250 North 5th Grand Junction (970) 244-1430 BUSINESS NAME Hawbew STREET ADDRESS 240 M PROPERTY OWNER Goudo OWNER ADDRESS Source ()]- 1. FLUSH WALL [] 2. ROOF [] 3. FREE-STANDING [] 4. PROJECTING [] 5. OFF-PREMISE [] Externally Illuminated (1 - 5) Area of Proposed Sign	2 Square Feet per 2 Square Feet per 2 Traffic Lanes - 4 or more Traffic	FEE\$_ Tax Scl Zone (CONT LICE ADDI TELE	ubmitted $7/1$ 79 25.00 hedule $2945-13-18-($ C-2 TRACTOR Buds Signs NSE NO. 299000 RESS 055 UTE Aug. EPHONE NO. $2NS-7700$ of Building Facade for Building Facade feet x Street Frontage quare Feet x Street Frontage	
Grand Junction (970) 244-1430 BUSINESS NAME Harber STREET ADDRESS 24 0 M PROPERTY OWNER Goudo OWNER ADDRESS Source ()] 1. FLUSH WALL [] 2. ROOF [] 3. FREE-STANDING [] 4. PROJECTING [] 5. OFF-PREMISE [] 5. OFF-PREMISE	2 Square Feet per 2 Square Feet per 2 Traffic Lanes - 4 or more Traffic	Tax Scl Zone (CONT LICE ADDI TELE	TRACTOR Buds Signs NSE NO. 299000 RESS 1055 UTE Ave. EPHONE NO. 295-7700 of Building Facade of Building Facade eet x Street Frontage

From:	Nina McNally
То:	Planning Techs
Date:	10/6/99 9:18AM
Subject:	2 Sign Permits

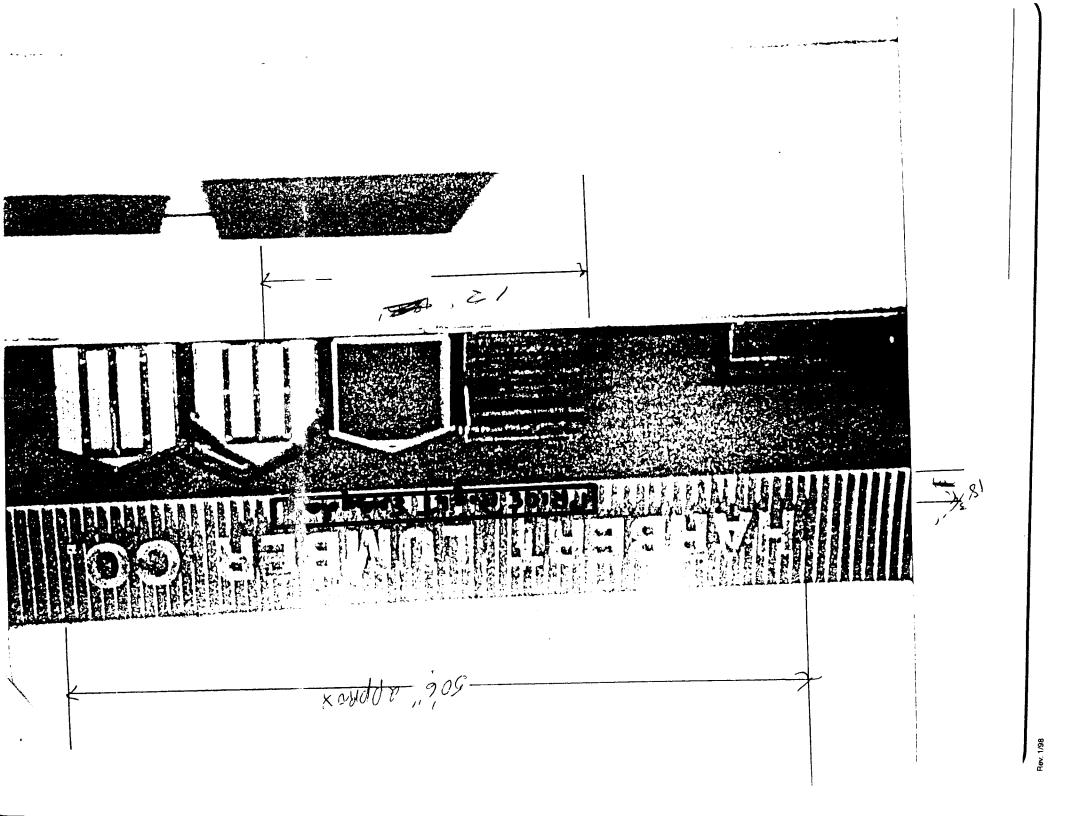
2) Harbert Lumber permit dated 7/1/99 did not include several signs on the building that say "Martin Seymor Paints" and they also have a large Sentry sign painted on the east side of the building to the west of their main building. The building appears on the sketch provided with the application.

NEED DIMENSIONS OF THESE SIGNS
